Inspection Report

Permit Number:	C0070005
Inspection Type:	PARTIAL
Inspection Date:	Tuesday, June 23, 2020
Start Date/Time:	6/23/2020 10:00:00 AM
End Date/Time:	6/23/2020 1:30:00 PM
Last Inspection:	Thursday, May 21, 2020

Permitee: **CANYON FUEL COMPANY**
 Operator: **CANYON FUEL COMPANY**
 Site: **SKYLINE MINE**
 Address: **HC 35 BOX 380, HELPER UT 84526**
 County: **CARBON**
 Permit Type: **PERMANENT COAL PROGRAM**
 Permit Status: **ACTIVE**

Division permitting staff discussed details of the Swen's canyon powerline installation with Canyon Fuels Co, LLC engineering and environmental staff and with Bill Broadbear, USFS Visual Impact Evaluator. The wooden power poles will hold a 46kV line, similar to those installed in Winter Quarter's Canyon. Mr. Galecki provided several maps as an overview of the power corridor installation, including a USFS map of temporary roads and timber sales. This packet is attached.

Skyline Mine
 Swens Canyon Powerline
 Special Use Permit Area

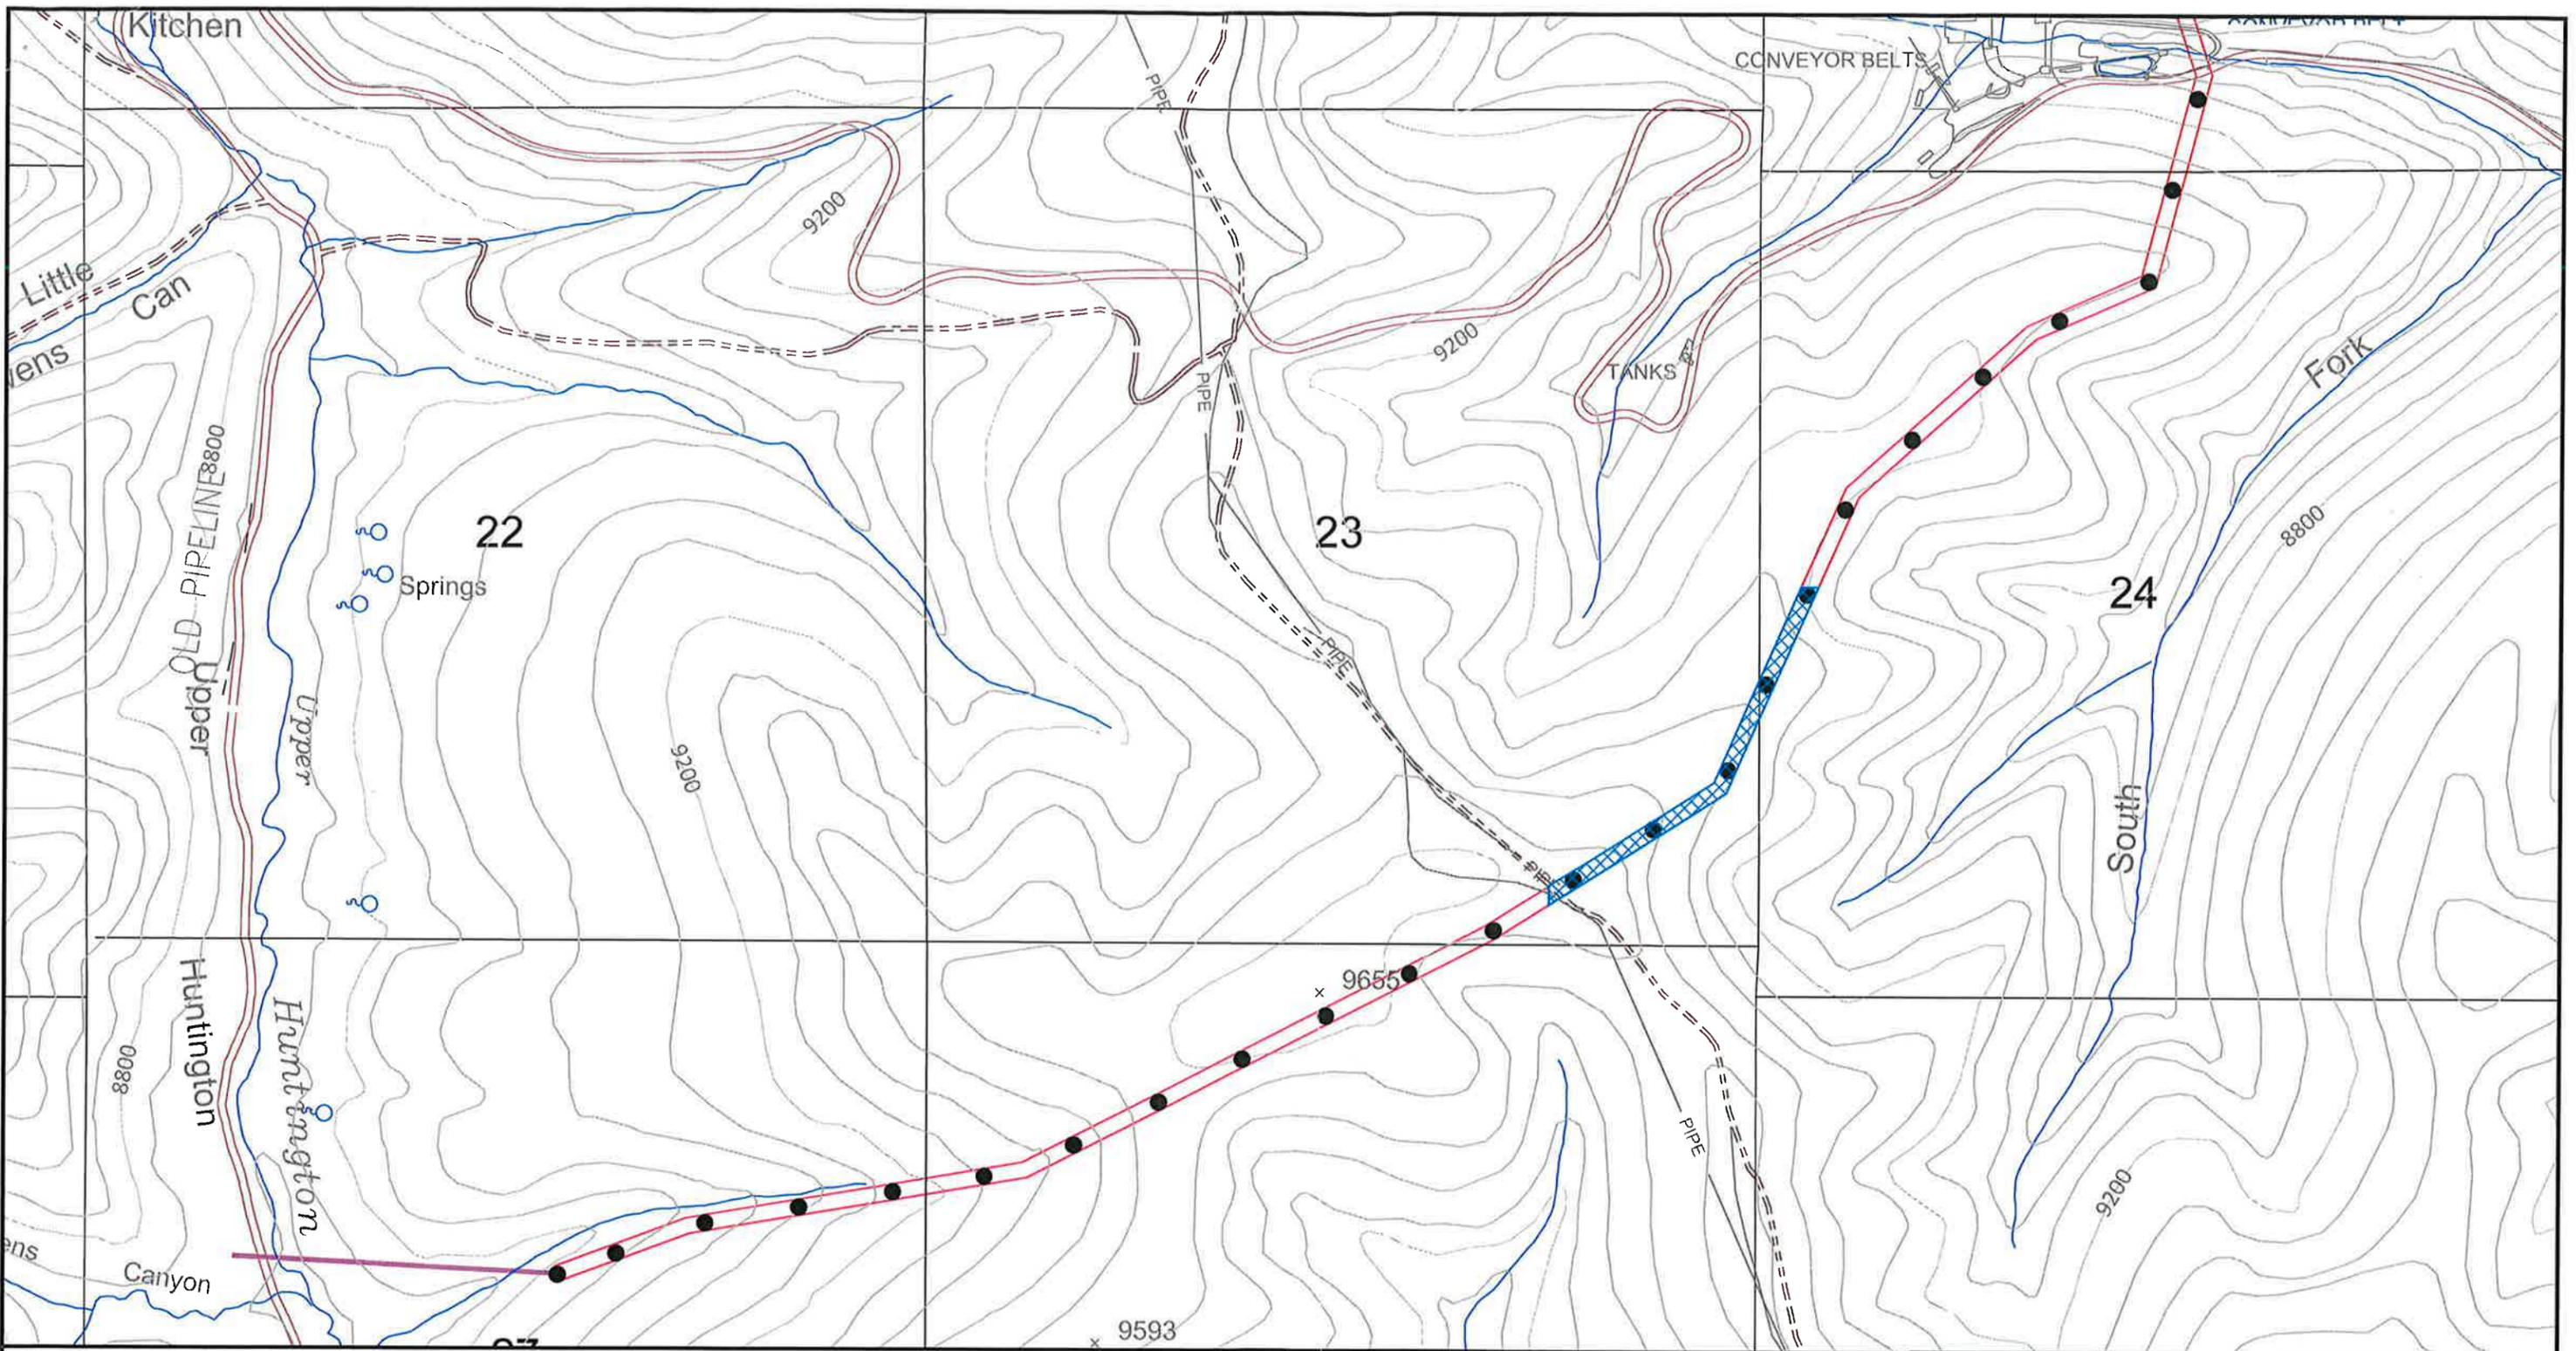
Permittee will obtain a road encroachment permit for the two locations where the powerline construction crosses Hwy 264 and a special use permit for where construction crosses USFS road 50018 on Trough Springs Ridge. Protecting the public through traffic control was discussed.

Skyline Mine
Swens Powerline
Clear Area

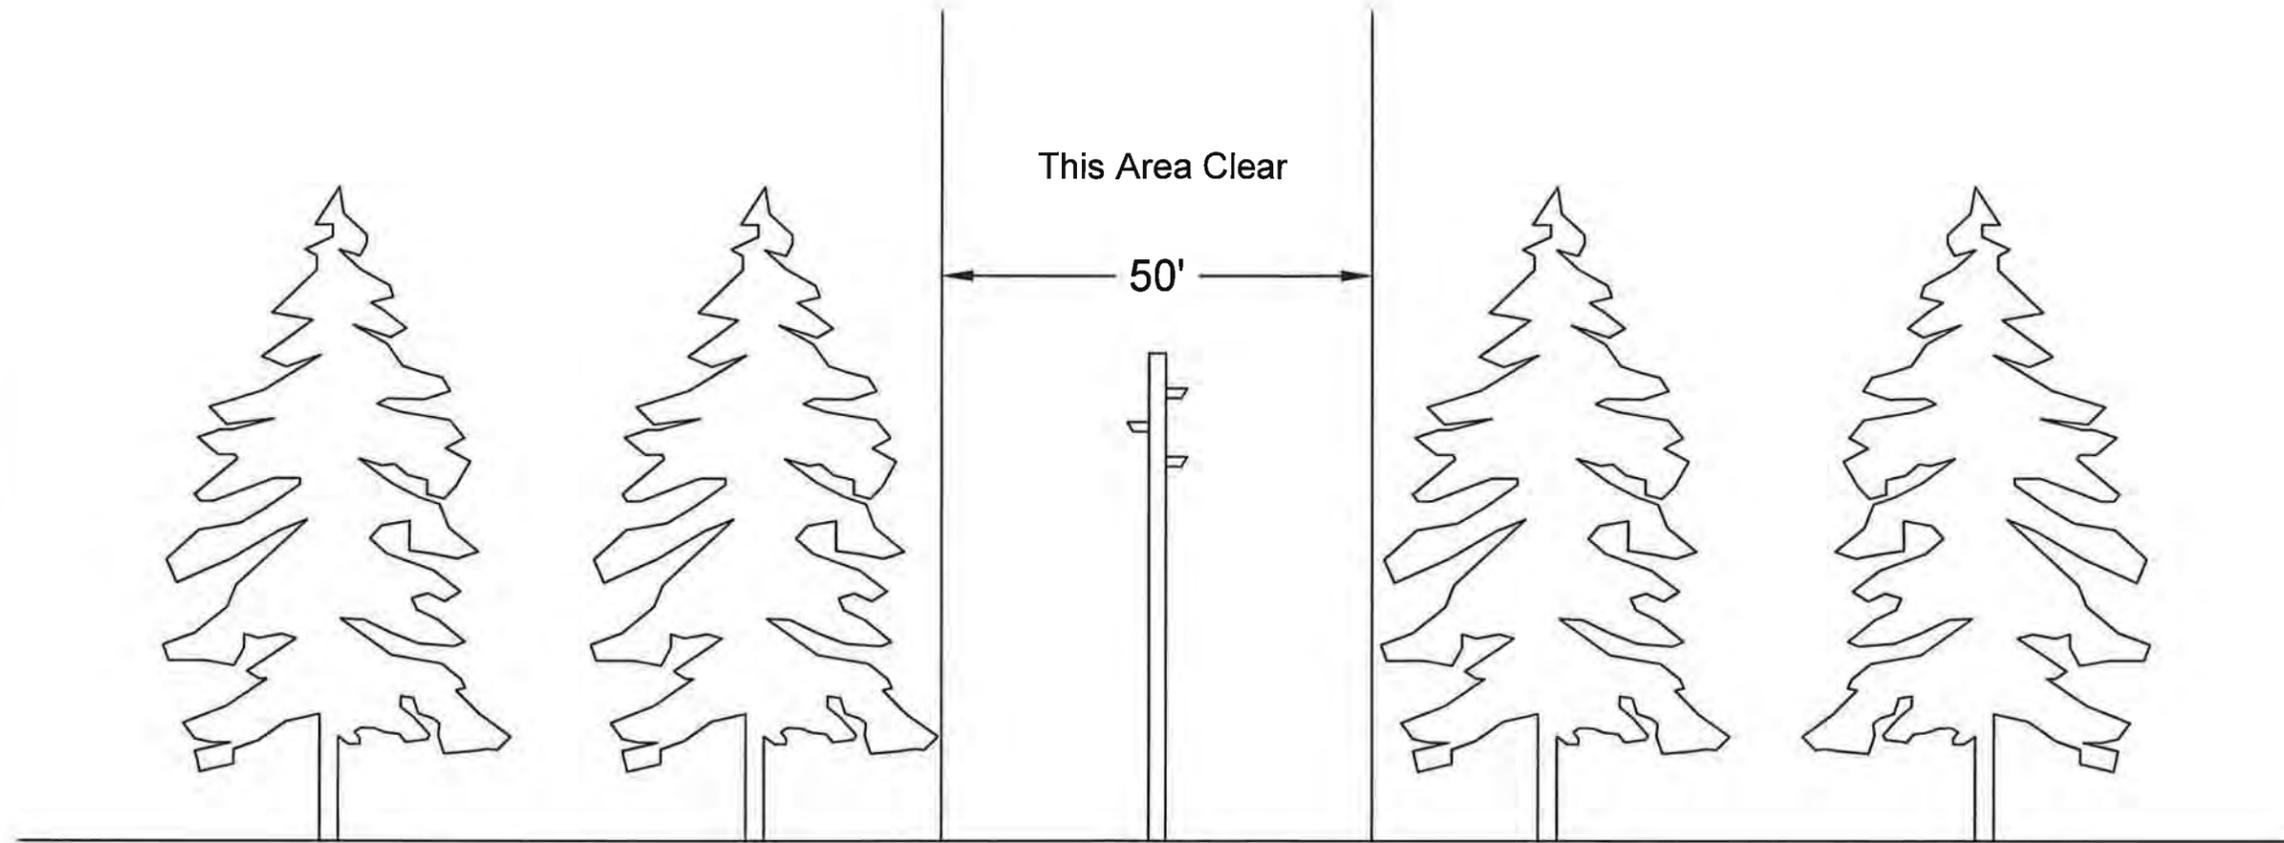
The Swen's Canyon powerline will be constructed within a 50 ft right of way as described in Task 6150, which is currently under review. Bodec Engineering has been selected as the contractor. Contract specifications will be available next week. The route climbs steeply from the mine site through evergreen forest up to Trough Springs Ridge. It crosses the aspen meadow on the ridge and drops down through an unnamed side canyon to Huntington Creek. It crosses the creek to the Swen's Canyon emergency escapeway/fan installation. The logistics of the installation were discussed.
